Change Notice

GB & GW Series

Changes to Location & Production for GB Pushbuttons & GW Rockers & Paddles

The original Change Notice CN-0369 released April 2021 is being reissued as CN-0369-A. The only new changes are the Effective Dates as shown below.

Changes for GB Pushbuttons & GW Rockers & Paddles

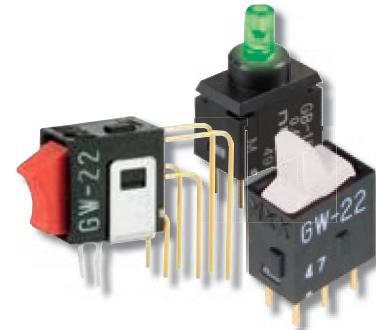
There will be revisions to the production and manufacture location for GB Pushbuttons and GW Rockers and Paddles, both illuminated and nonilluminated in each series. Previously, the lot code on the switch body had a dot mark above the first digit, but now the dot mark will be above the second digit. The shipping box for these pushbuttons, rockers or paddles had "CHINA FACTORY" on the side, but will be replaced with "PHILIPPINES FACTORY." These changes will apply to standard and custom GB Pushbuttons and GW Rockers. Effected standard part numbers for GB Series are below, and standard GW Series part numbers are on page 2.

Lot Number	Shipping Box
Before Changes	Dot Mark Above First Digit  Enlarged to Show Detail	
After Changes	Dot Mark Above Second Digit  Enlarged to Show Detail

Changes for GB Series will be effective **May 2022**. Changes for GW Series will be effective **June 2022**.
